Addendum No.: 6

Date Of Addendum: September 28, 2017

**Fire Alarm & Sprinkler Project  
Veterans' Home – 287 West Street  
Rocky Hill, CT  
BI – C – 285 / FAI Number 09-016**

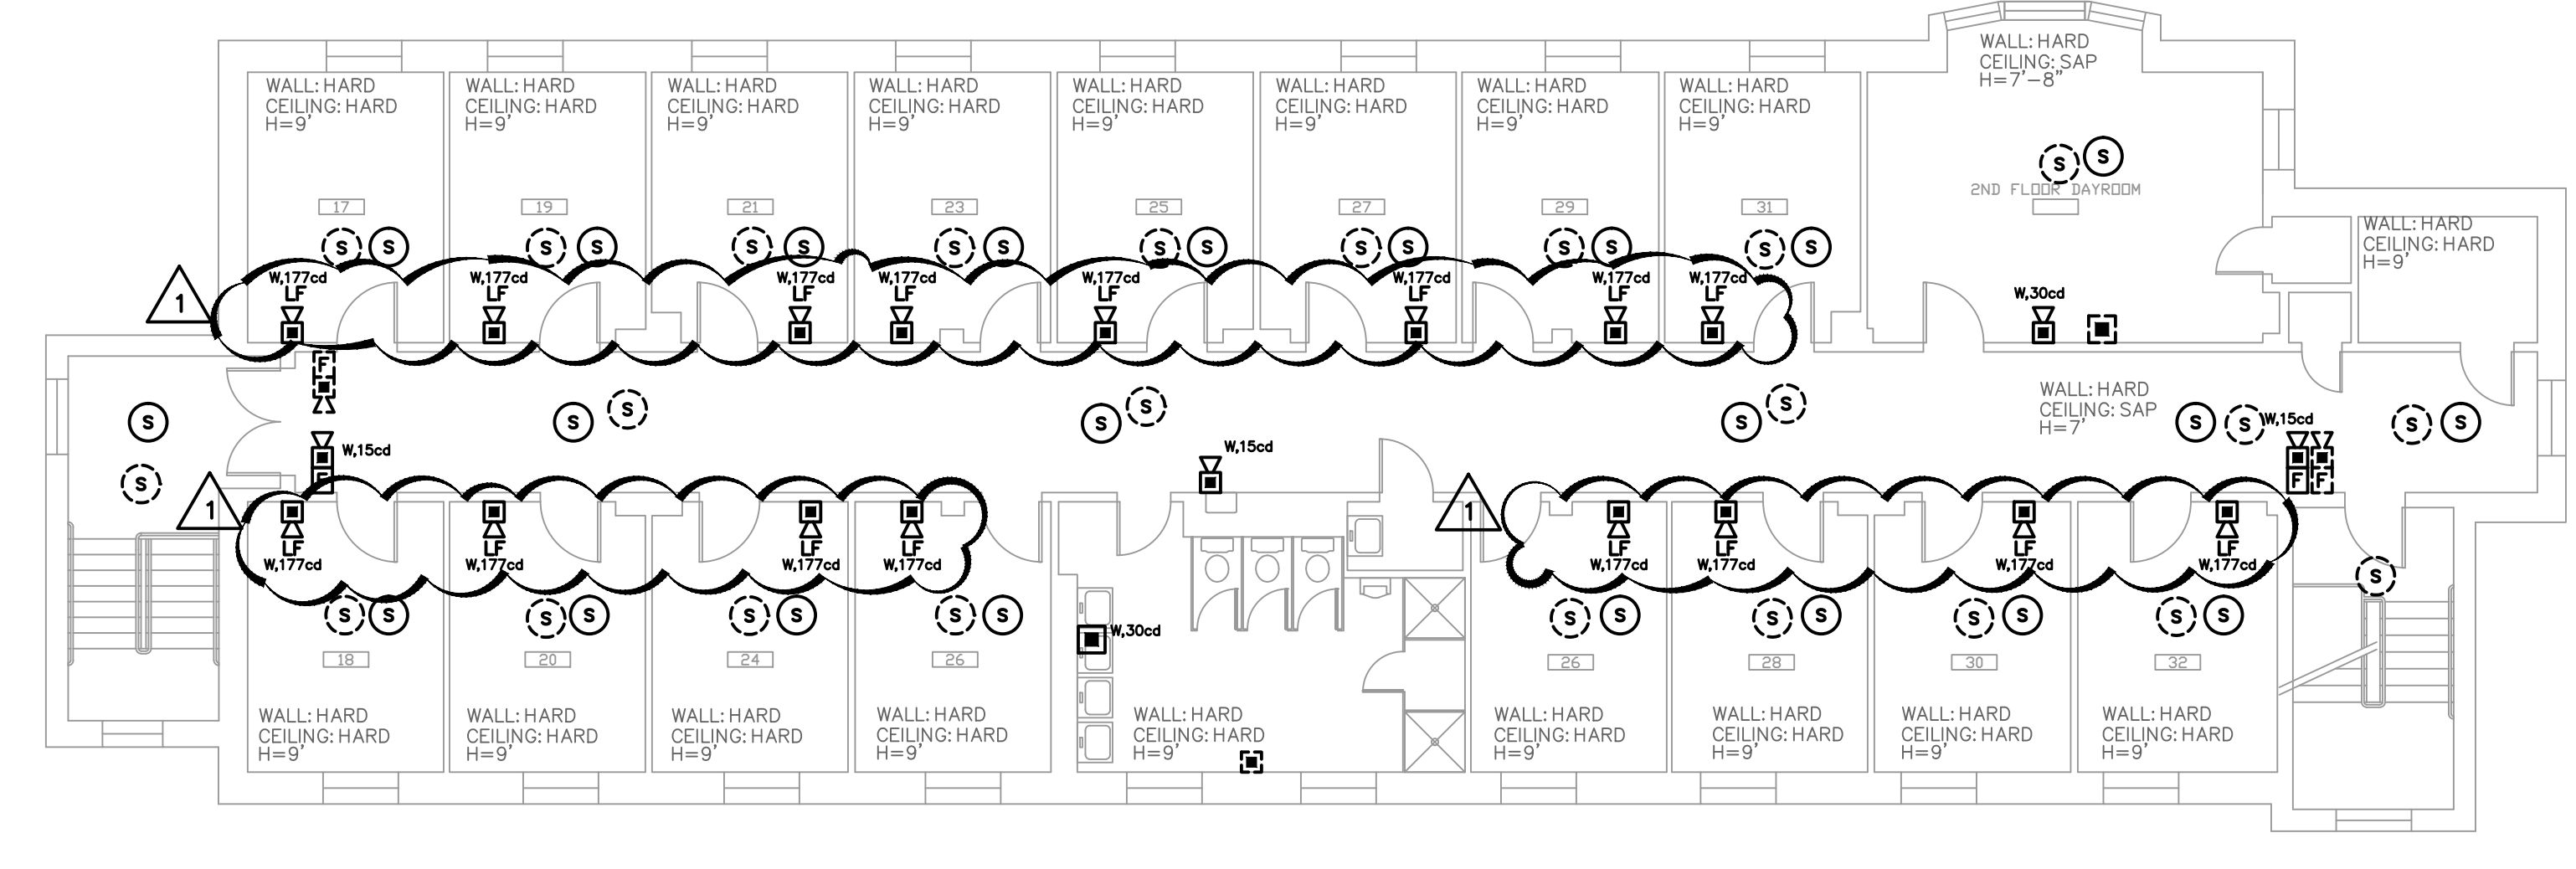
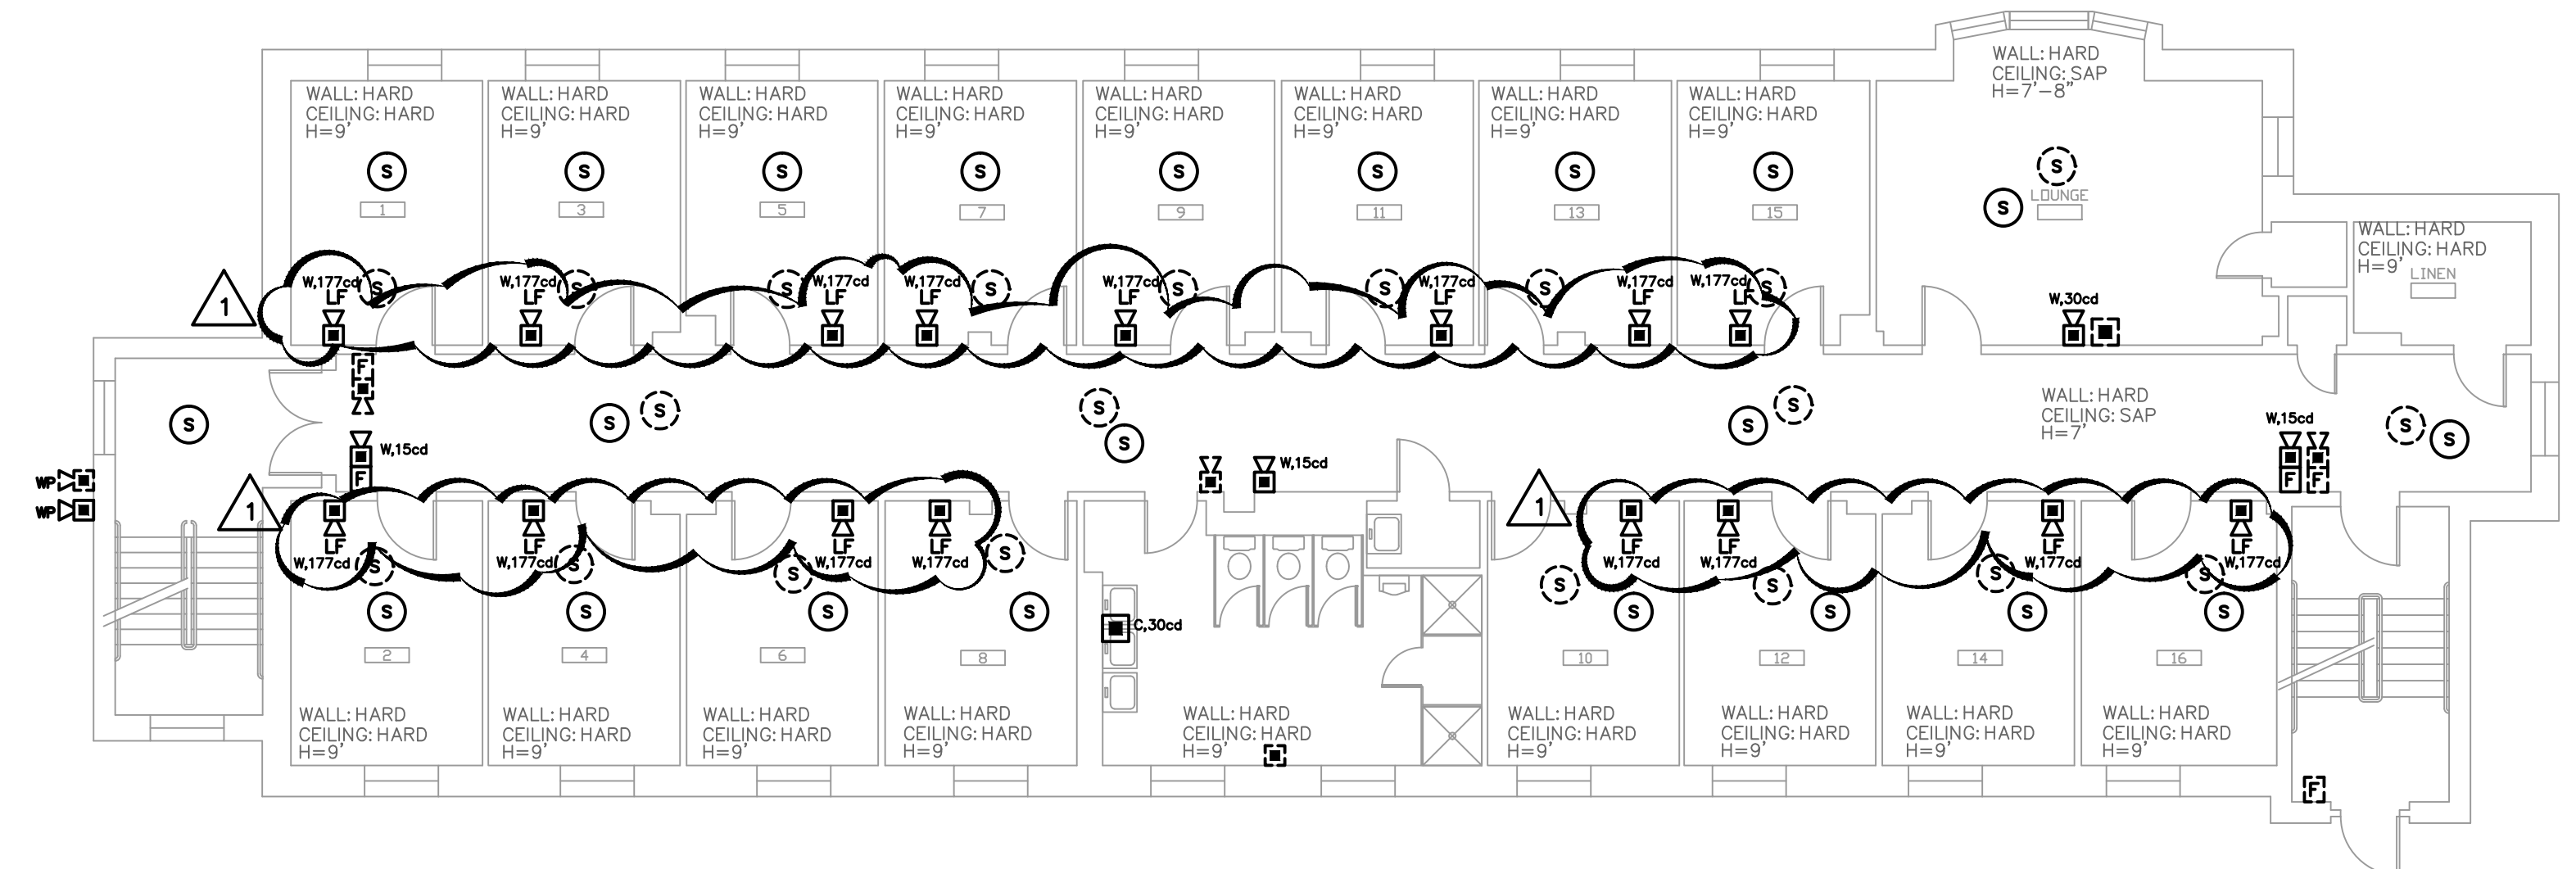
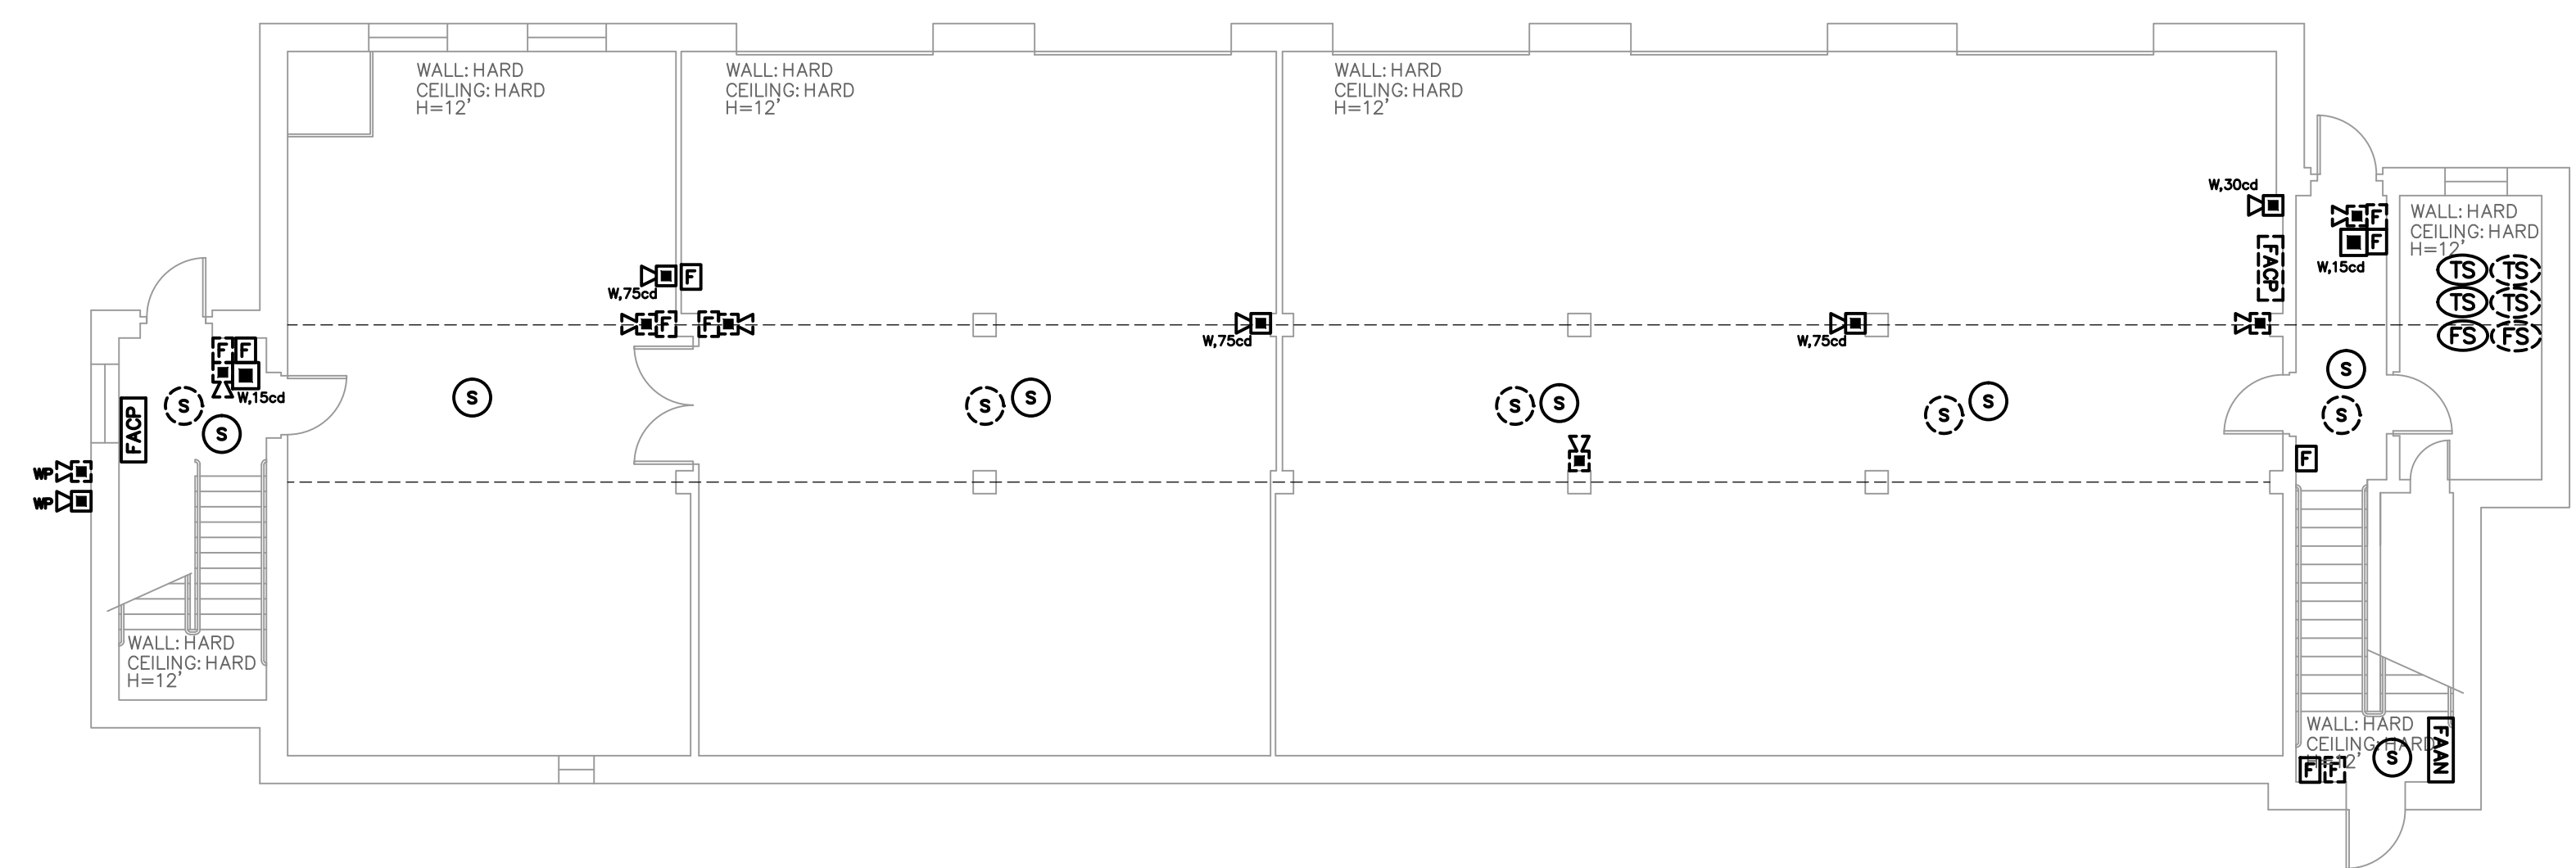
Building's #3, #4, #50, #52 - Horn/strobes within sleeping areas shall have low frequency sounder. See revised drawings FA103.1, FA103.2, FA104.1, FA104.2, FA150.0, FA150.1, FA150.2, FA150.3, and FA152.0. Low frequency sounders shall meet the requirements of NFPA 72 – 2010 18.4.5.3.
